# Access Compliance Report

## Public Rights-of-Way

### (Pedestrian Signals)

Intersection ID: N/A	Main Street:	Cross Street: N/A	Location: N/A
ADA ID: 3D4898594B9A	Signal Type: One Push Button-Non APS	Overall Compliance: No	Severity Score: BTN 1: N/A BTN 2: N/A No BTN: N/A
Codes/Mitigation Info/Possible Solution		Field Measurements/Component Compliance

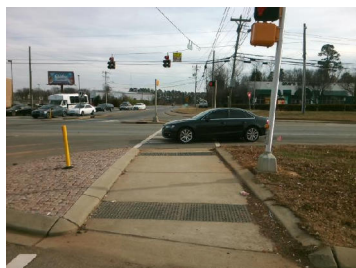
PROW/ADA: TMUTCD 4e.08, R406.2, R404.7.3, R404.7.2

Possible Solutions: Replace Signal Push Button With APS Button on New Post. Remove & Relocate Sign.
